Product Change Notice (PCN)

Subject: Change of assembly and test sites for Renesas EEPROM TSSOP Halogen-Free products

Appendix for 22-0007A

Change of assembly site and Final test site for Renesas EEPROM TSSOP Halogen-Free products.

内装箱 Inner box

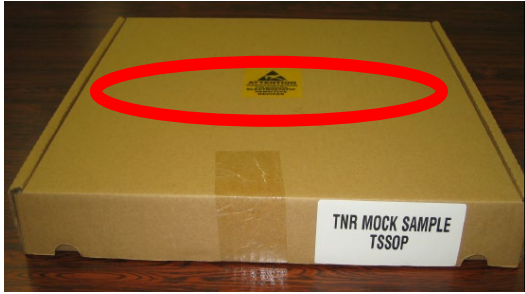
(Pre change:ATP product)

ルネサスロゴなし There is no logo mark of RENESAS

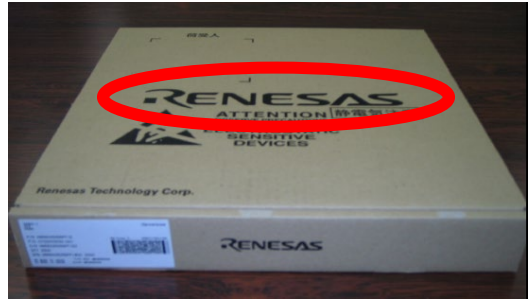
(Post change:MVC product)

ルネサスロゴ有 There is a logo mark of RENESAS

緩衝材 Cushioning material

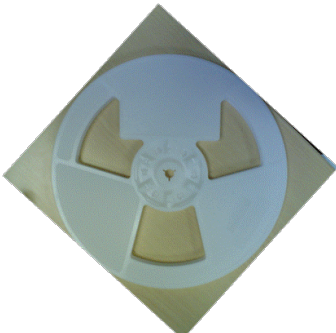
(Pre change:ATP product)

シールド袋、エアキャップあり
Shielding Bag with Bubble bag

(Post change:MVC product)

なし None

リールの色 Reel's color

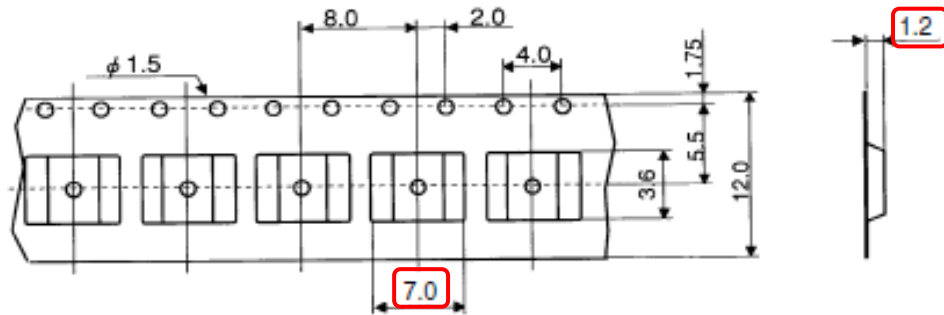
(Pre change:ATP product)

白 White

(Post change:MVC product)

黒 Black

エンボステープ仕様 Embossed tape dimensions (TSSOP-8)

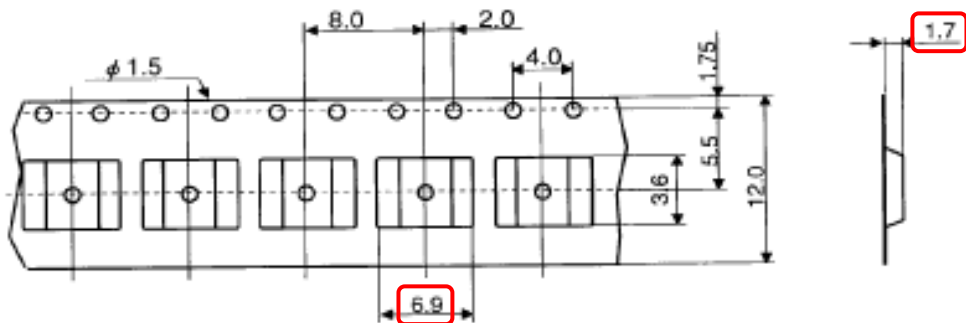
(Pre change: ATP product)

型名 (Tape type)	ADVANTEK TSSOP8
材質 (Material)	ポリスチレン (PS)
表面抵抗値 (Surface resistance value)	$1 \times 10^5 \Omega / \square$ 以下 $1 \times 10^5 \Omega / \square$ or less

パッケージコード (Package code)	TTP-8DAV
収納数 (storage No.)	A 3000 IC/内装箱 3000 IC/Inner box

(Post change: MVC product)

型名 (Tape type)	TE1208-7P
材質 (Material)	ポリスチレン (PS)
表面抵抗値 (Surface resistance value)	$1 \times 10^7 \Omega / \square$ 以下 (less than $1 \times 10^7 \Omega / \square$)

パッケージコード (Package code)	TTP-8DA TTP-8DAV
収納数 (storage No.)	3000IC/内装箱 (3000IC/Inner box)

リール仕様 Reel dimensions (TSSOP-8)

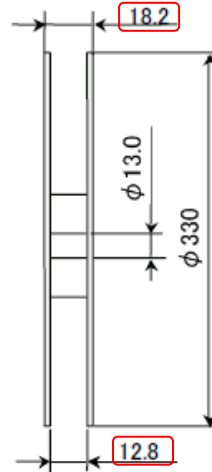
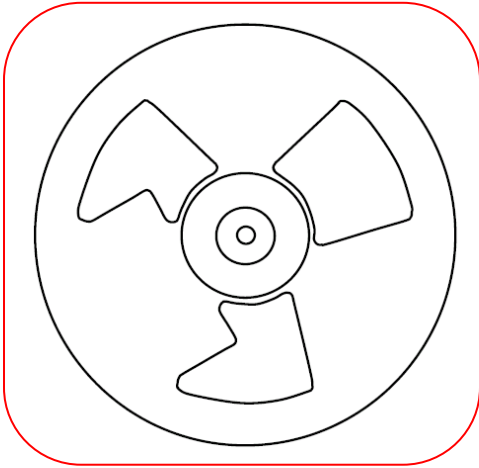
(Pre change:ATP product)

リール (Reel)	φ330 プラスチックリール (12mm 幅用) φ330 Plastic reel (for 12mm width)
材 質 (Material)	ポリスチレン (PS)
表面抵抗値 (Surface resistance value)	$1 \times 10^9 \Omega / \square$ 以下 $1 \times 10^9 \Omega / \square$ or less

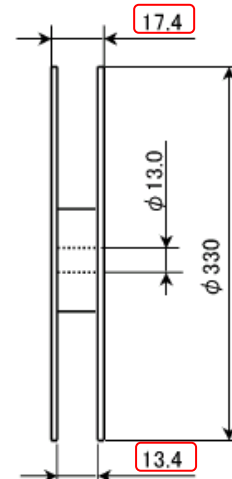
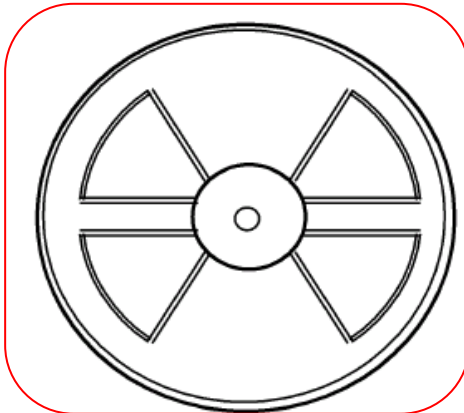
(Post change:MVC product)

リール (Reel)	φ330プラスチックリール(12mm幅用) φ330 plastic reel (For 12mm width)
材 質 (Material)	ポリスチレン (Polystyrene)
表面抵抗値 (Surface resistance value)	$1 \times 10^9 \Omega / \square$ 以下 (less than $1 \times 10^9 \Omega / \square$)

There is no difference in an important size, and is no problem in use though there is a possibility where something that the design of the flange of the reel is somewhat different depending on the difference etc. of the molding metal mold exists.
